Director-Infrastructure Projects
Department of Planning and Environment
GPO Box 39
Sydney NSW 2001

I wish to lodge my objection to the route of the shared cycle and pedestrian pathway (western option E) and its southern extension to Chuter Avenue as outlined within the Preferred Infrastructure Report (PIR) 2019.

Figure 5: Vegetation map showing the cumulative impact option E route will on the Patmore Swamp Freshwater Wetland EEC

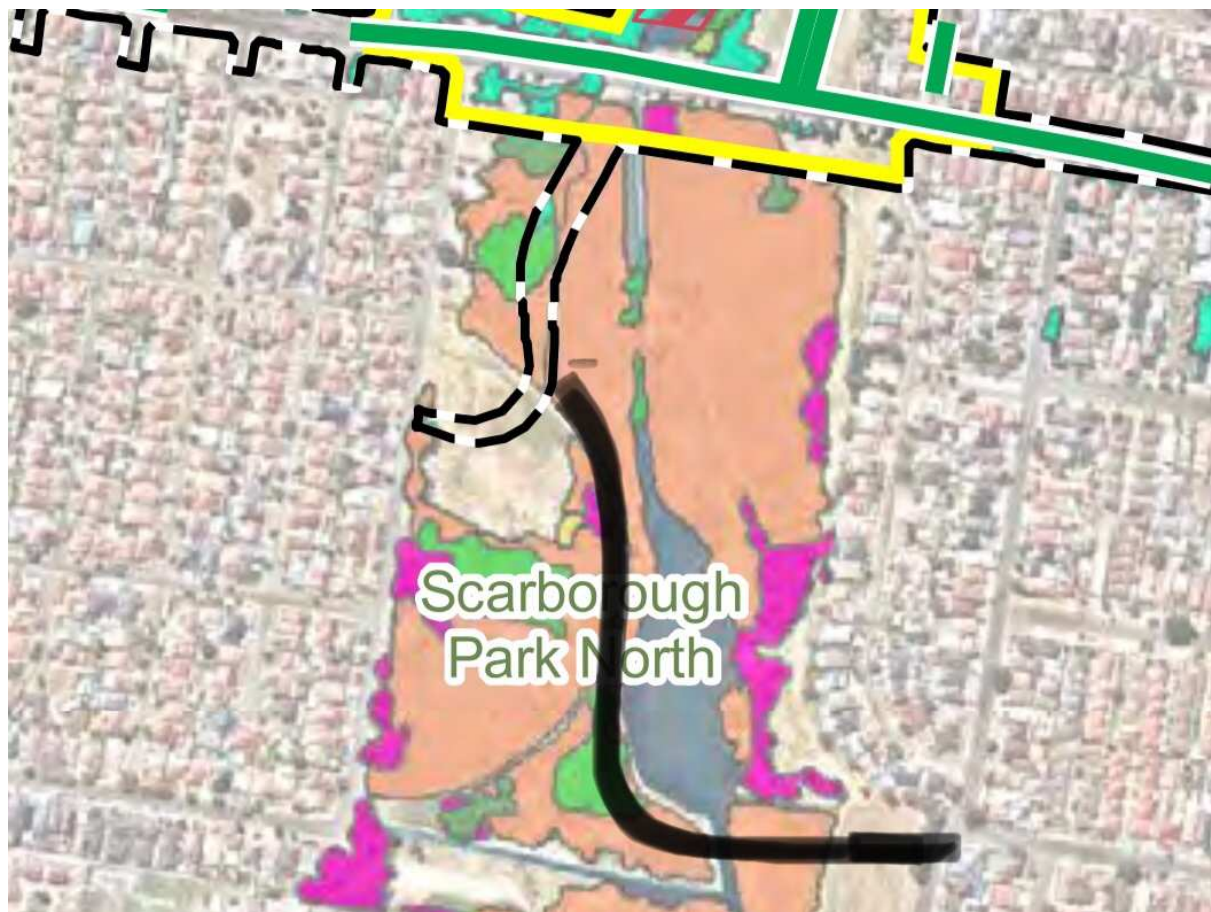
The combined Option E route and raised boardwalk will impact two of the best stands of Coastal Freshwater Swamp Forest within Patmore Swamp (see Fig 5)

The PIR does not acknowledge the cumulative impact of the southern extension boardwalk on the ECC Freshwater Wetland within Patmore Swamp. Patmore Swamp will lose almost a hectare of endangered common reed (1808) in total if the proposed option E shared pathway and extension goes ahead.

The reedland to be removed is amongst some of the finest stands of reedland contained within the swamp. Not only does the direct removal of reed land need to be considered. The remaining broad vista reed landscape will be interrupted as the shared pathway will cut through the middle of it.

I cannot determine the total figure of Coastal Freshwater Swamp Forest (1232) currently existing in Patmore Swamp nor the percentage cumulative loss due to the option E route and extension as this figure is not provided within the PIR or EIS.
